Preservation Department – Item 6, LPC-24-06787

260-264 Waverly Avenue – Clinton Hill Historic District
Borough of Brooklyn

Changes in response to Commissioners' Comments at the Dec 10, 2024 Public Hearing:

Primary facade (East)

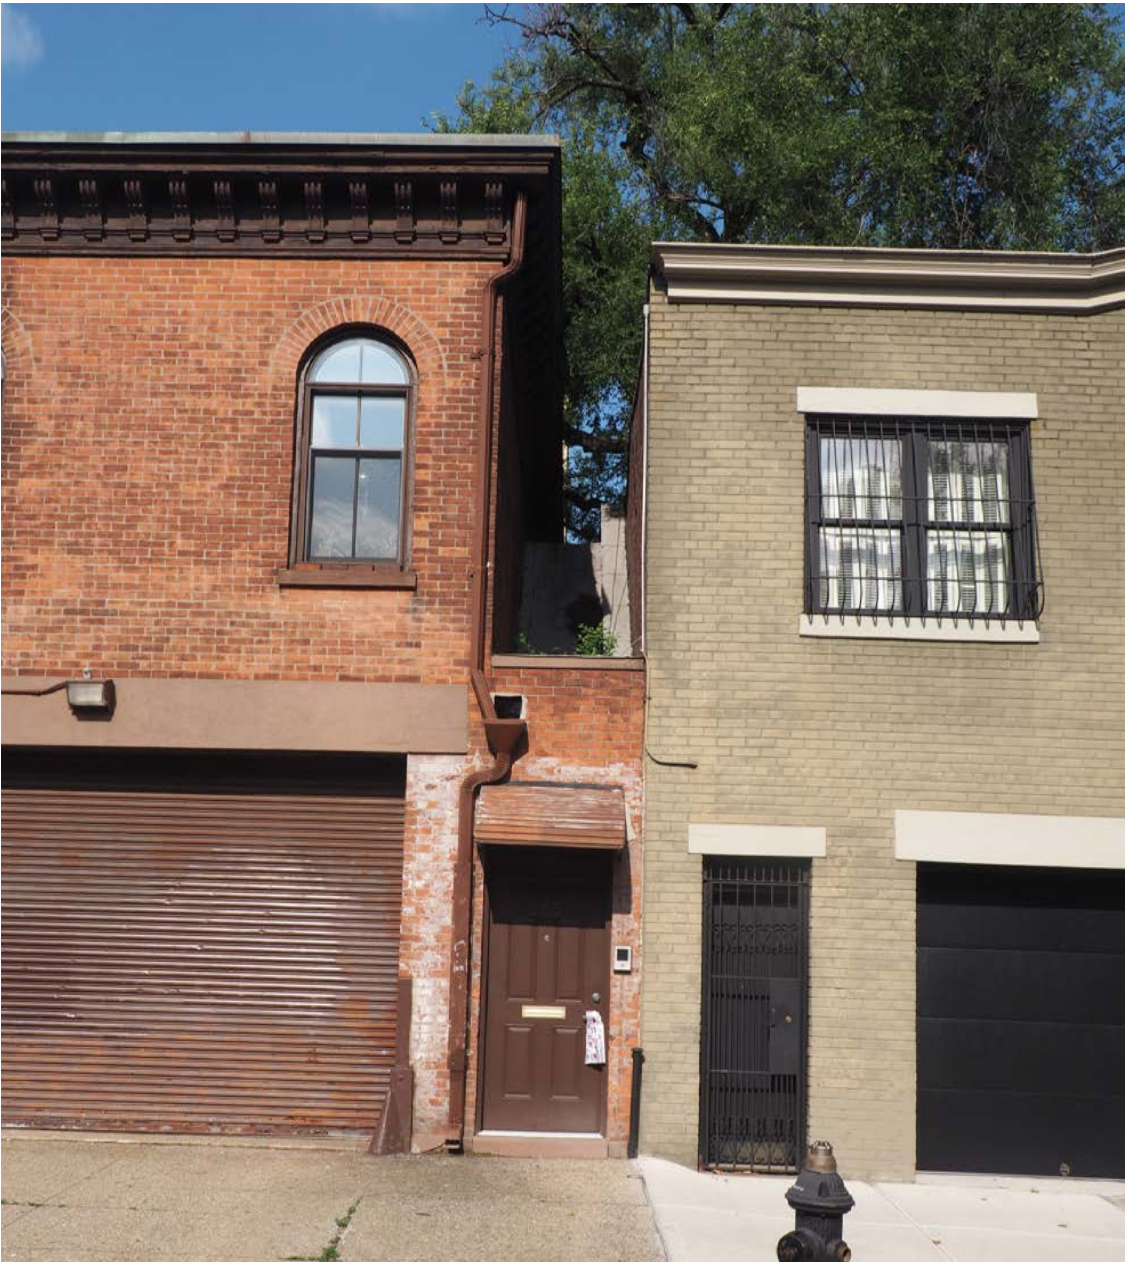
- 1. Wood Cornice to be removed and new dentilled brick cornice recreated to match rear façade design.
- 2. Restudied the solid-to-void ratio to retain more masonry
- 3. Central 2nd floor window enlargements reduced in size to maintain varied fenestration pattern.
- 4. Entrance no longer separated from windows.
- 5. Lintel height raised to 10’ throughout first floor to match garage.

North facade

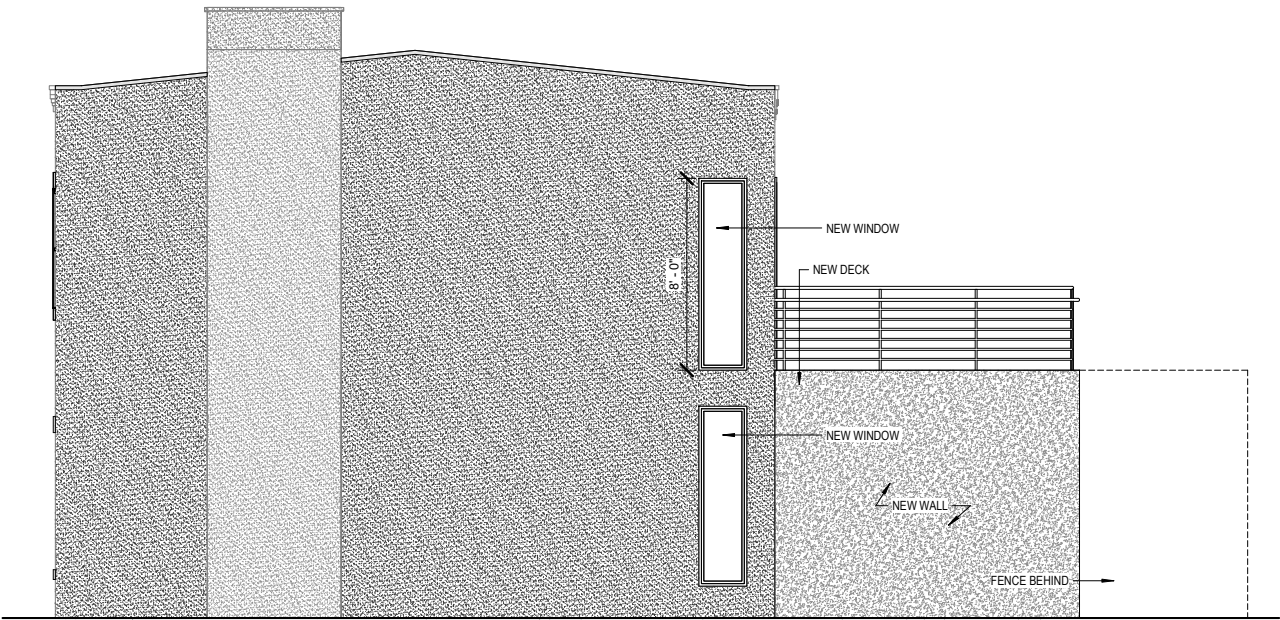
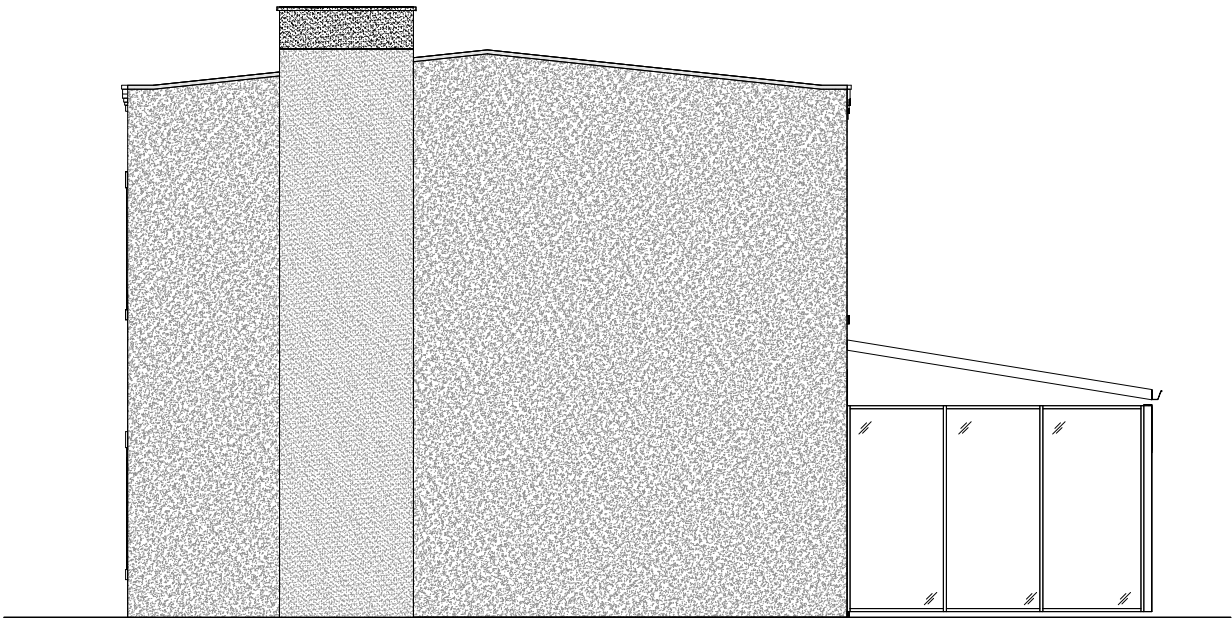
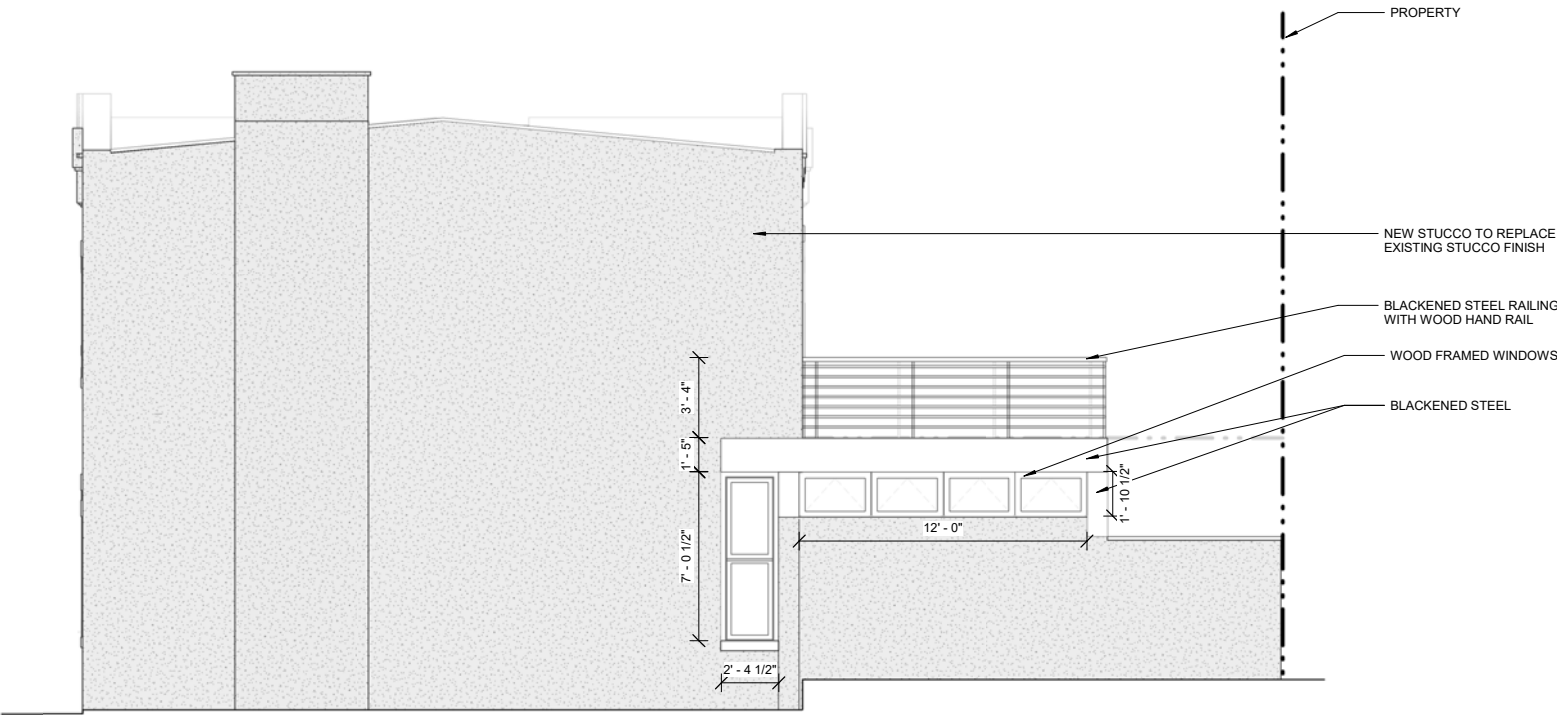
- 1. Double hung window has been added to the side wall.
- 2. 2nd floor window eliminated.
- 3. Clerestory added to addition.
